SUBJECT: PLANS AND PROPOSAL ADDENDUMS

PROJECT: F 2023(060)

CONTROL: 0089-10-026

COUNTY: WHARTON

**BRIDGE RAIL AND MBGF SUMMARY AND LAYOUT**  
NOT TO SCALE

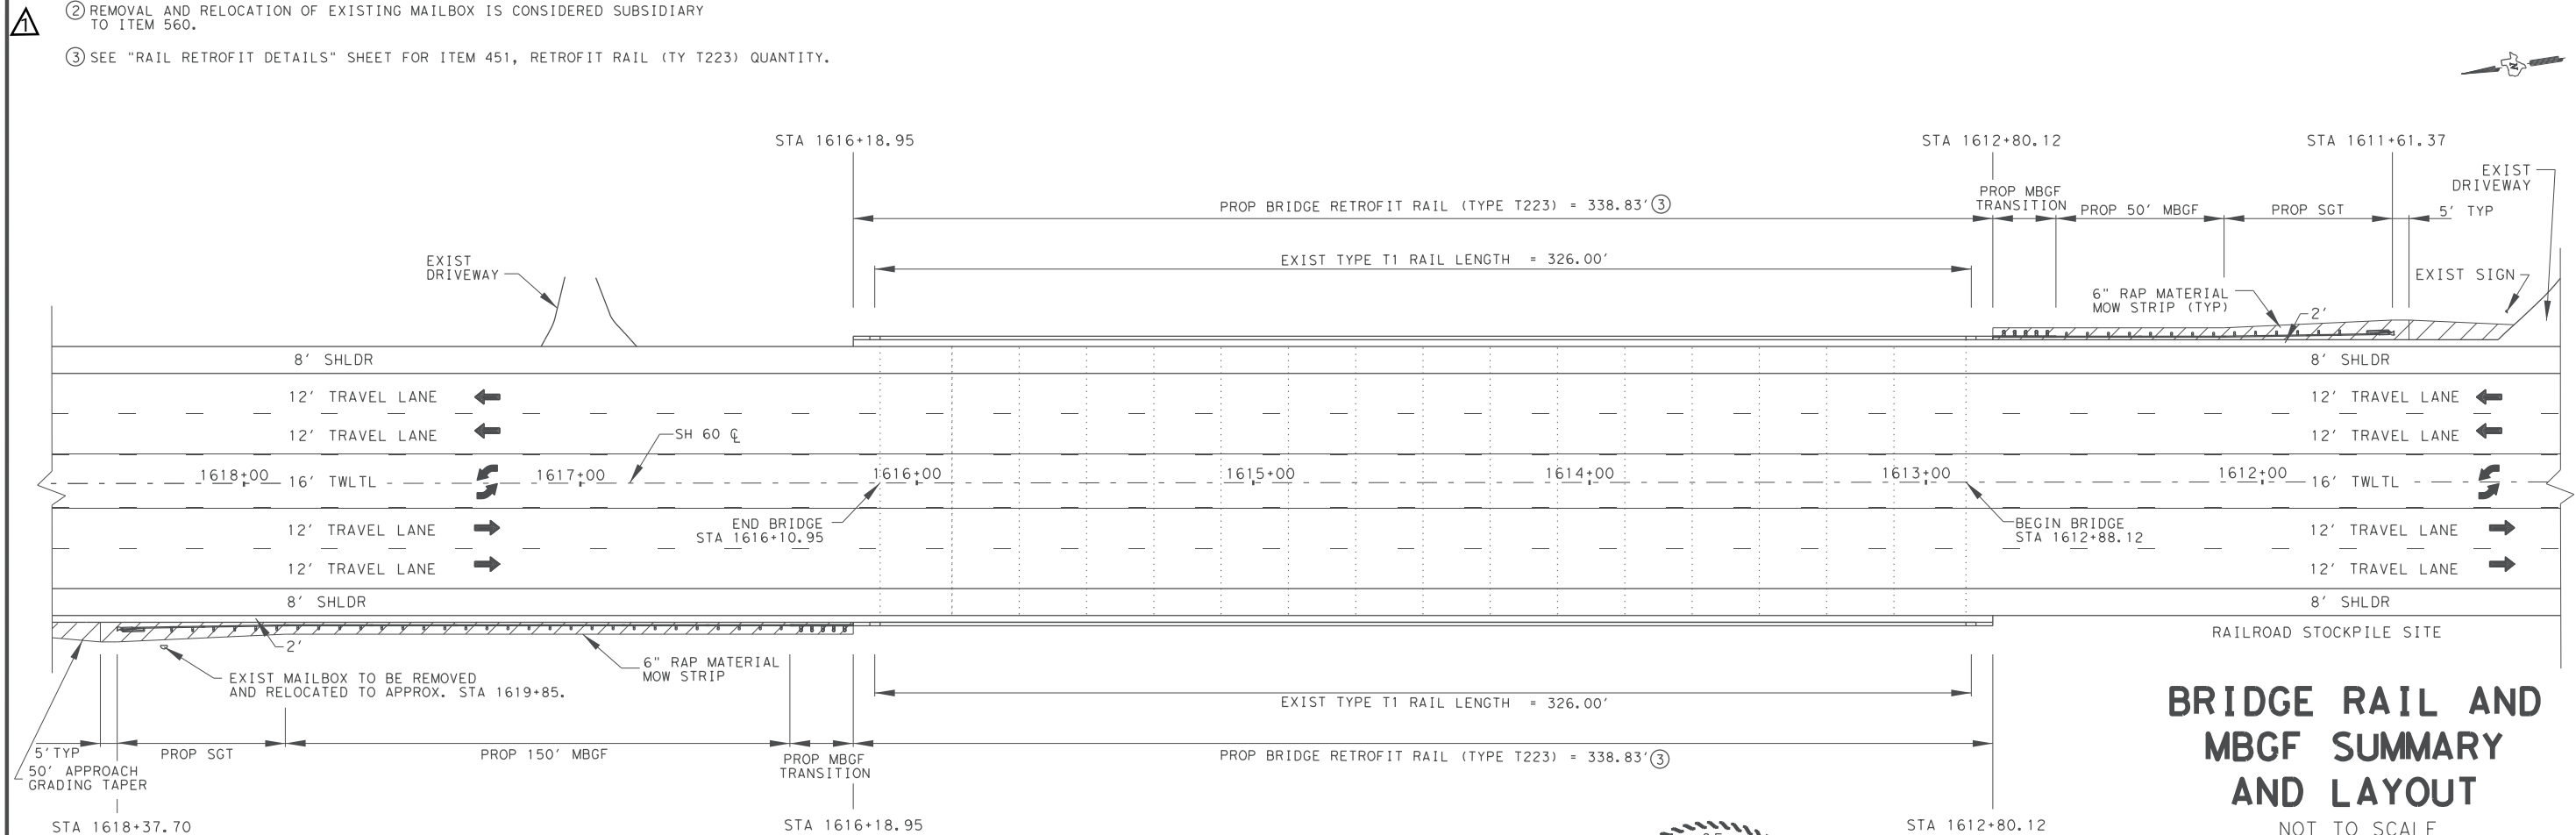
SHEET 48 (BRIDGE RAIL AND MBGF SUMMARY AND LAYOUT): DELETED ITEM 450-6018  
REPLACED WITH ITEM 451-6019, REVISED QUANTITY FOR ITEM 451-6007 AND  
AND ADDED NOTE 3

# BRIDGE RAIL AND MBGF SUMMARY AND LAYOUT

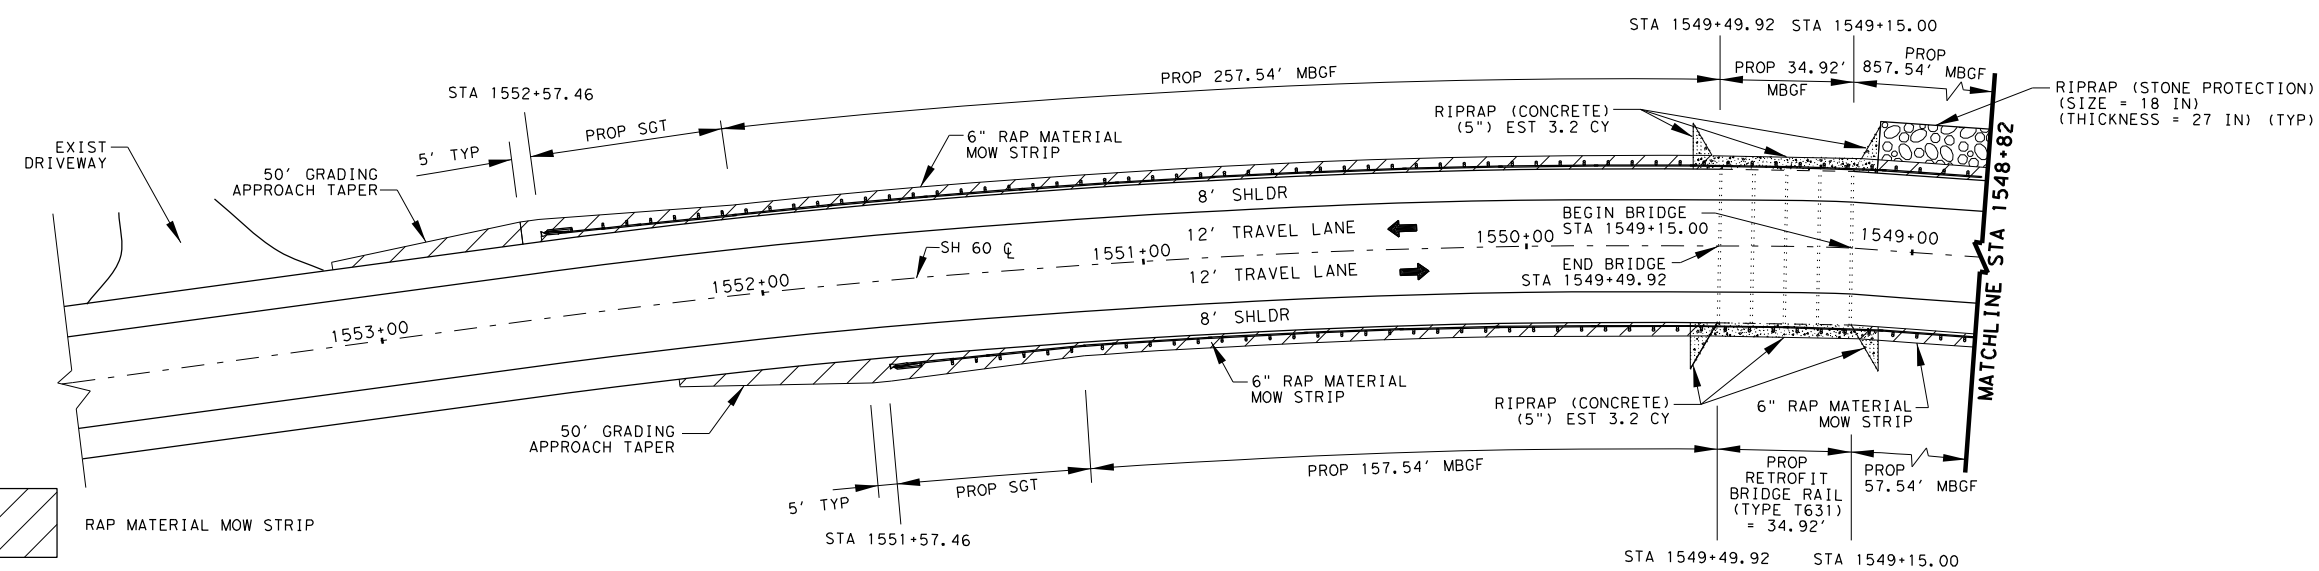
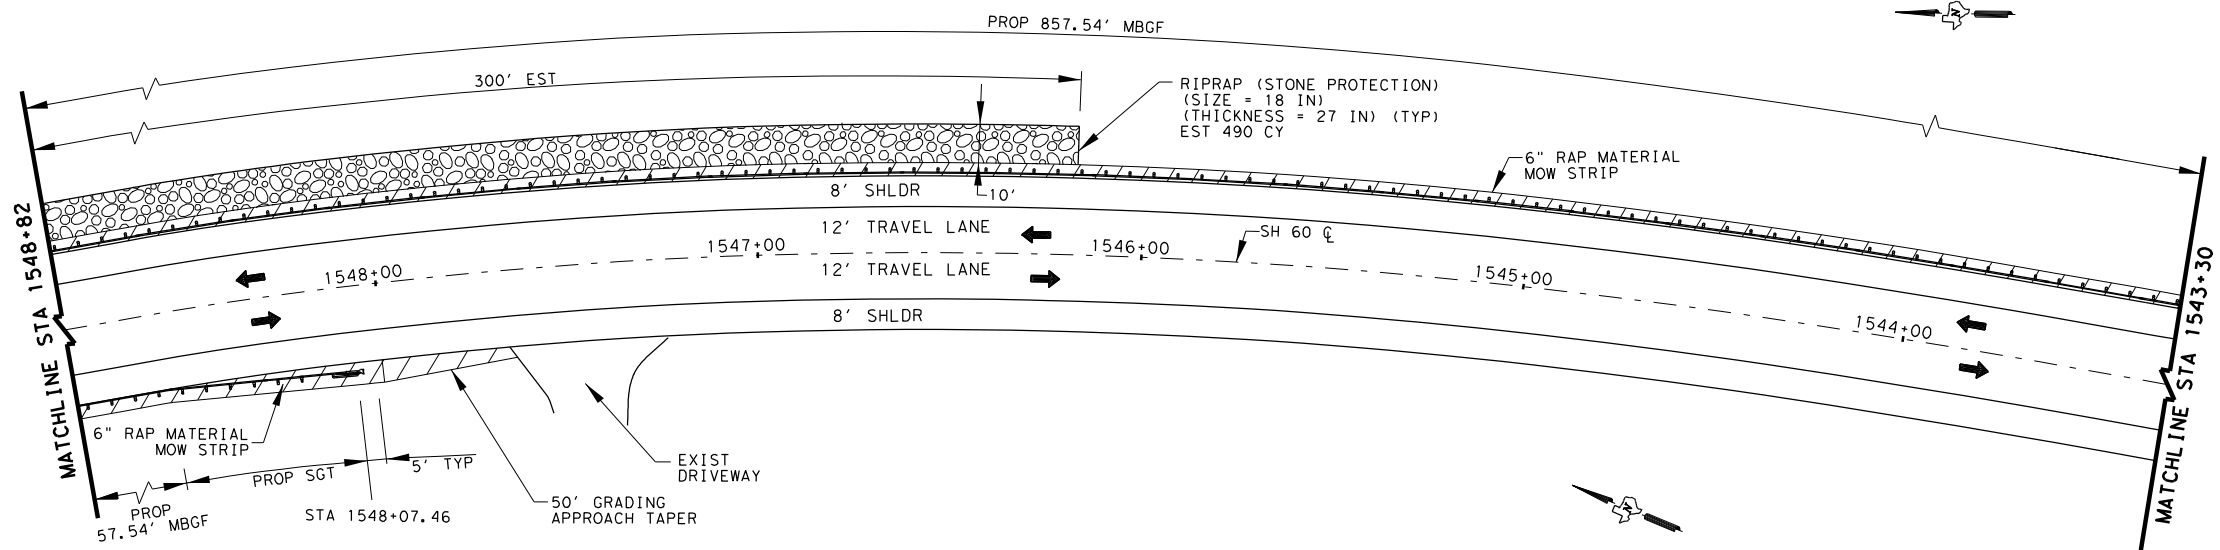
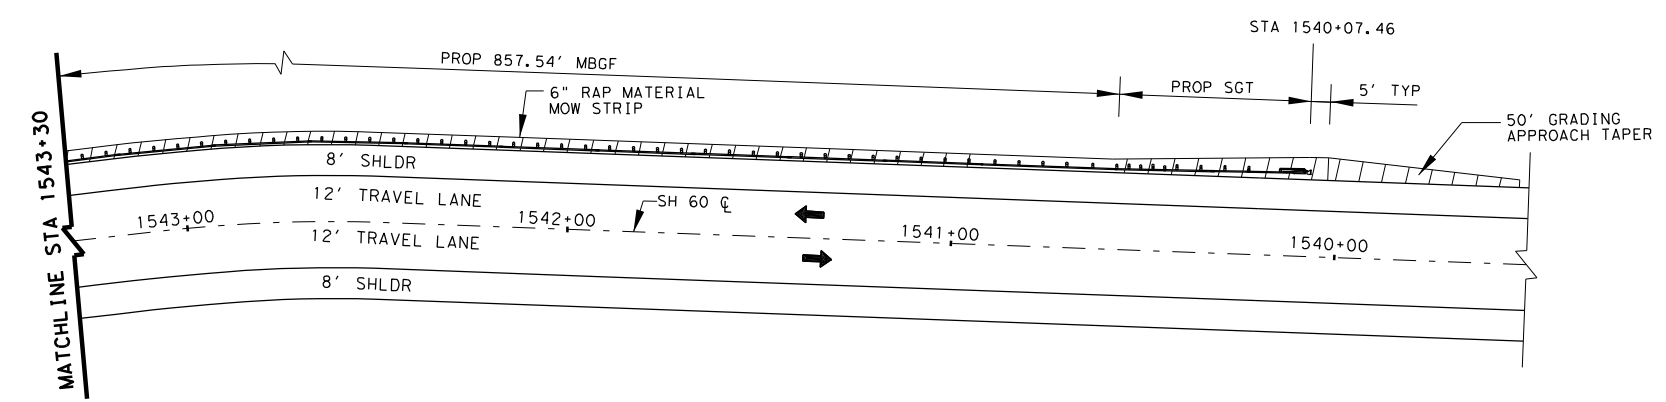
SHEET 49 (BRIDGE RAIL AND MBGF SUMMARY AND LAYOUT): CHANGED RAIL TYPE  
DESCRIPTION OF ABOVE CHANGES (CONTINUED)  
(INCLUDING PLANS SHEET CHANGES)

Texas Department of Transportation		Bridge Division	
<b>RAIL RETROFIT DETAILS</b>			
SH 60 AT PEACH CREEK BRIDGE			
FILE: SH060_BRG_RL497m01.dgn	DN: CG	CK: HTP	DW: SFS
REVISIONS	CONT	SECT	JOB
0089	10	026, ETC	SH 60, ETC
DIST	COUNTY	SHEET NO.	
YKM	WHARTON, ETC	66A

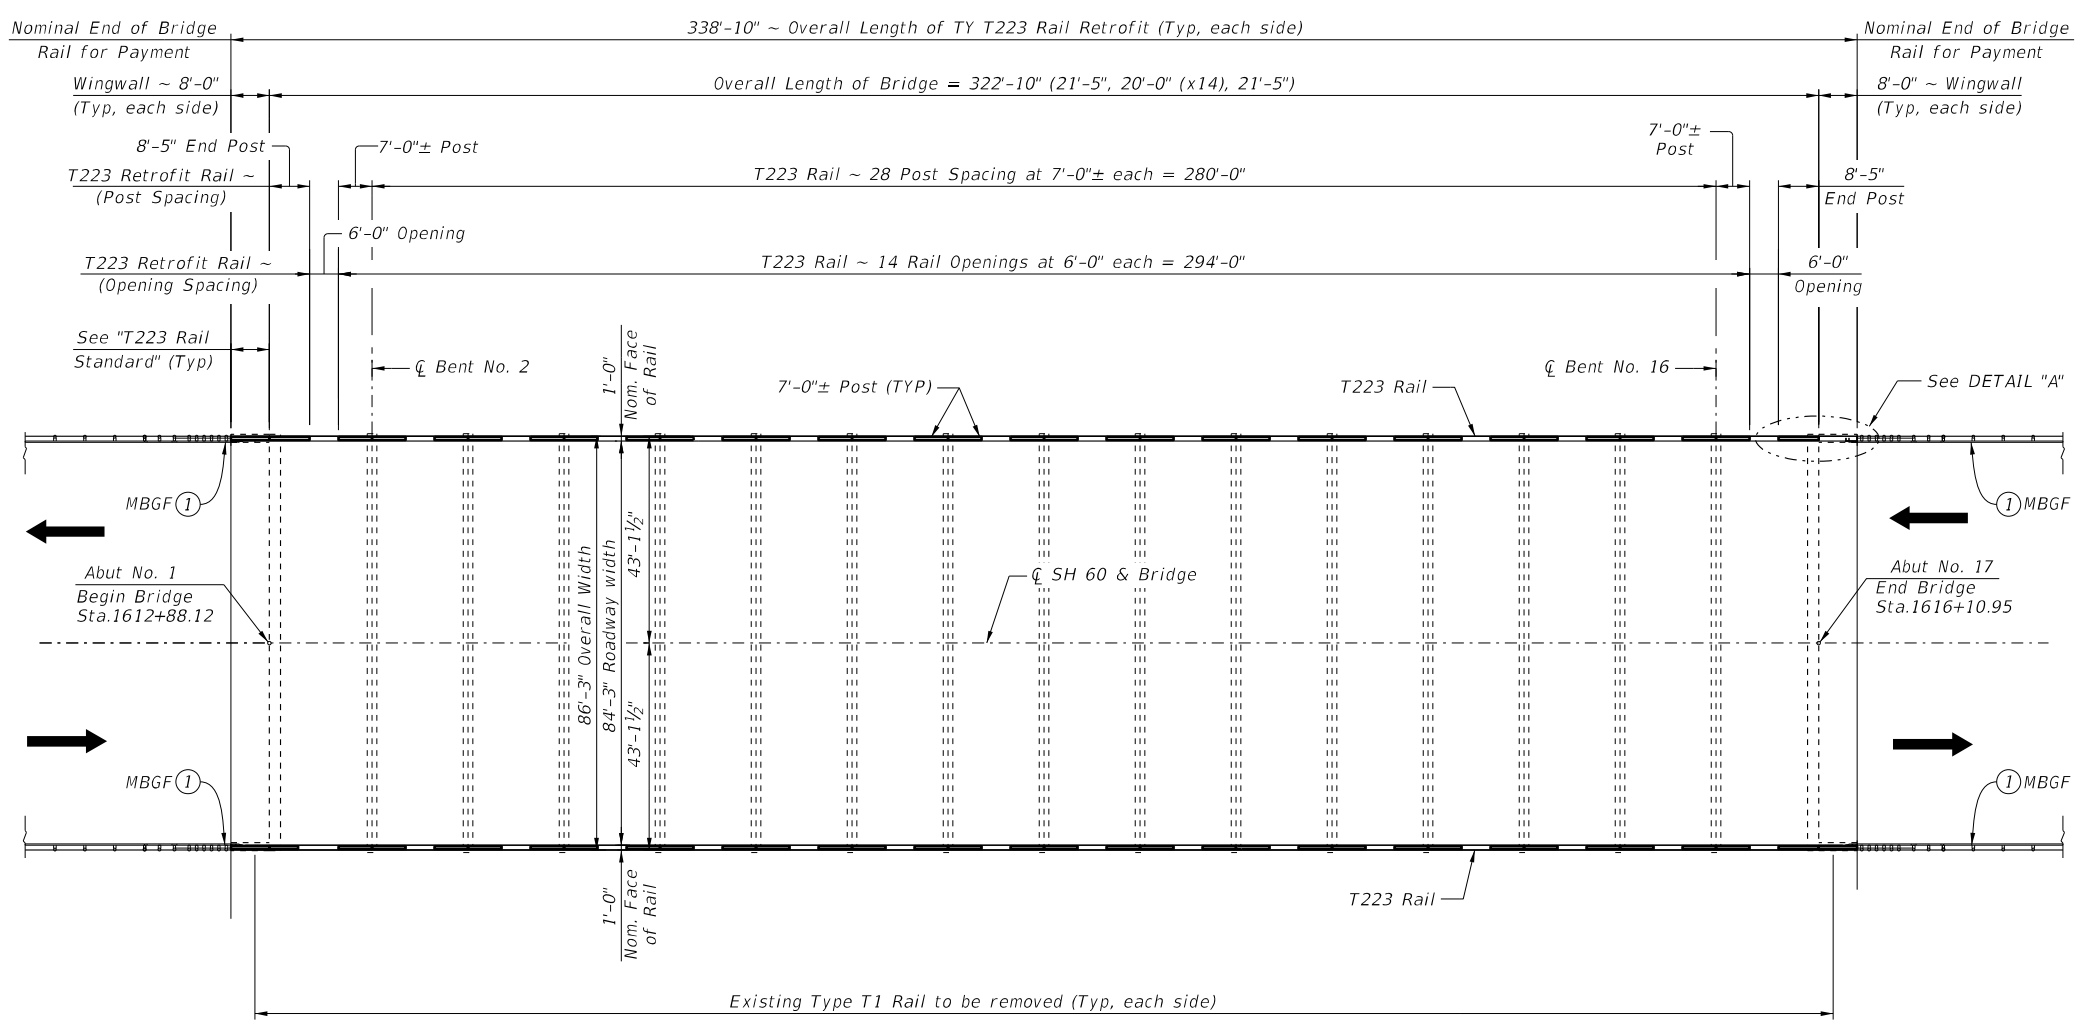
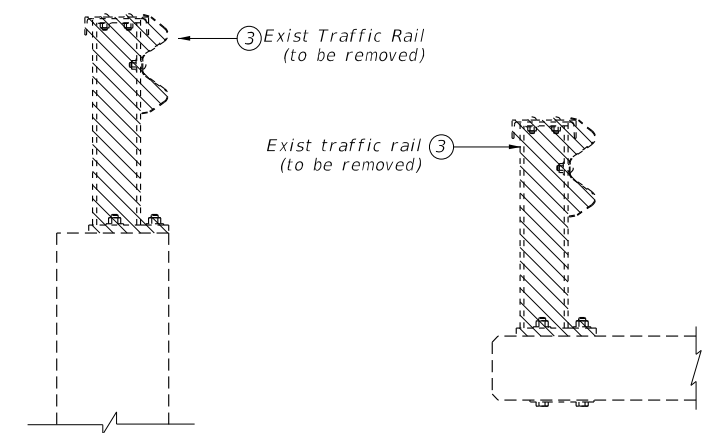
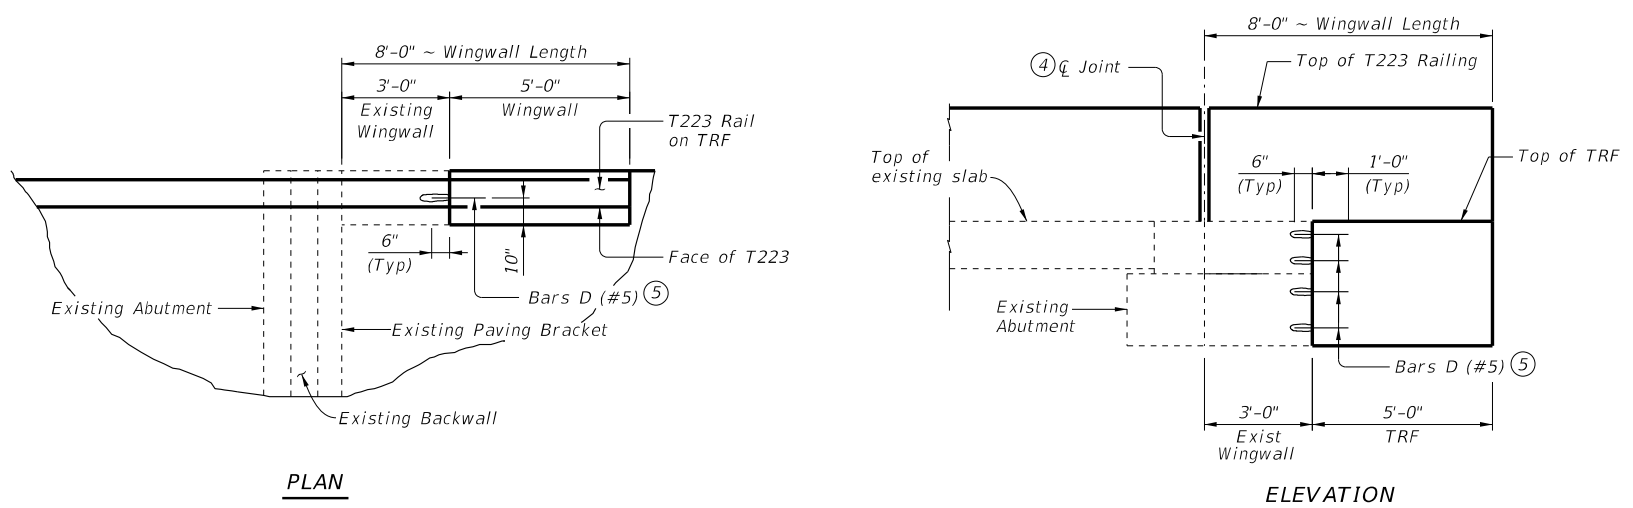
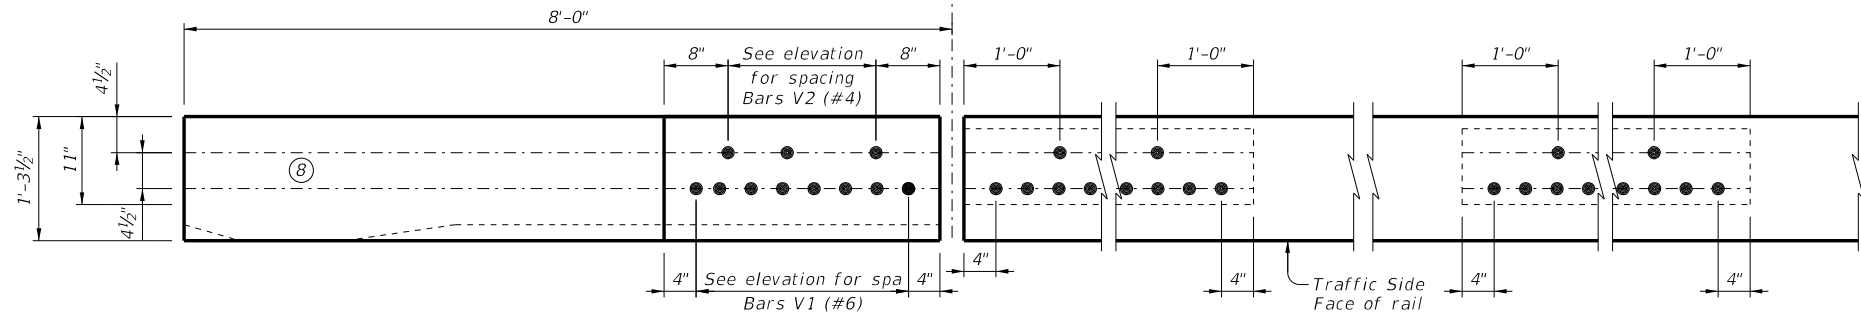
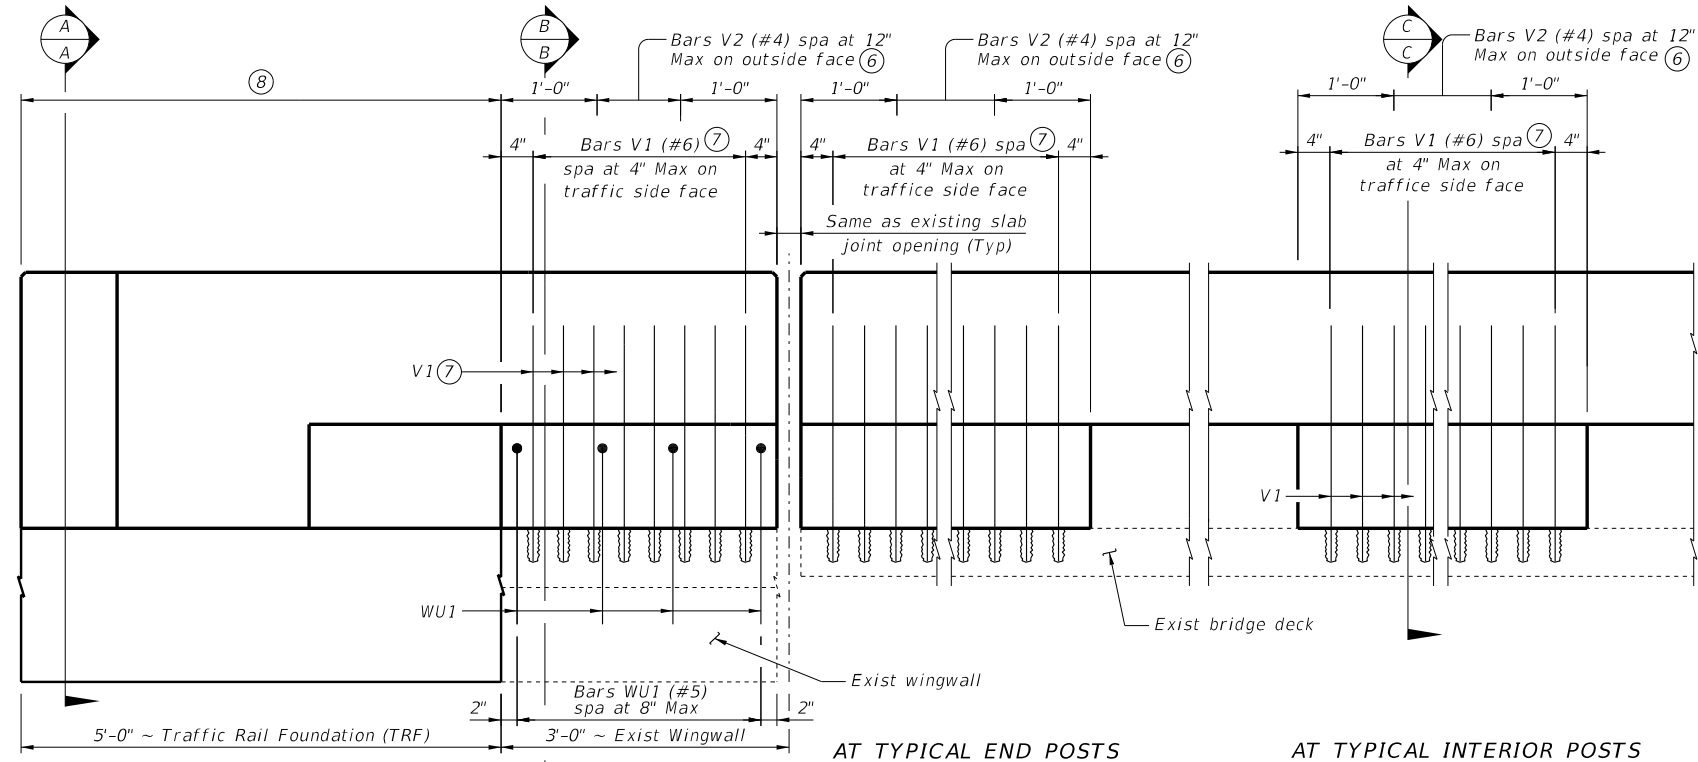
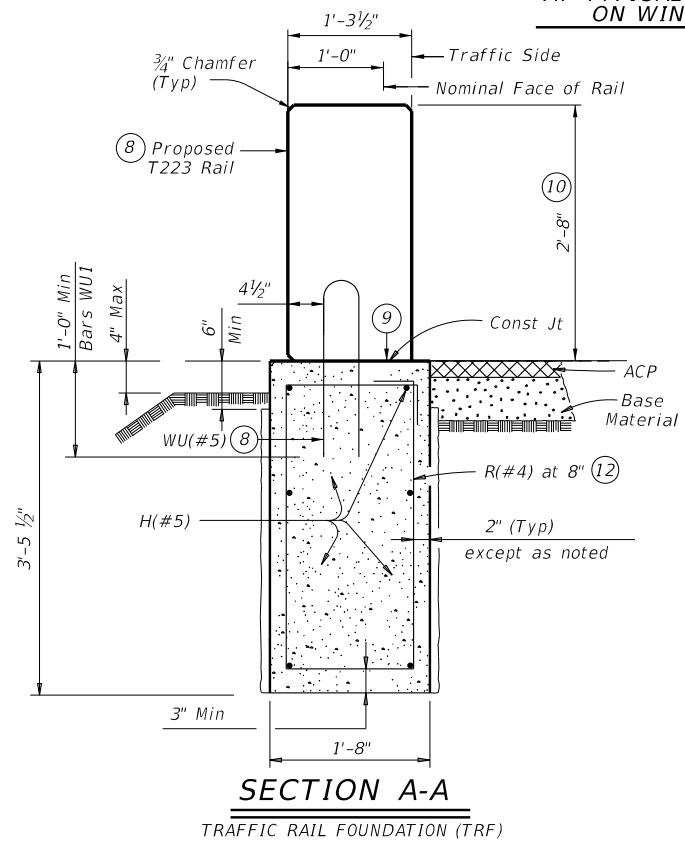
SHEET 66A (RAIL RETROFIT DETAILS) : ADDED TO PLANS TO CLARIFY CONSTRUCTION  
DETAILS
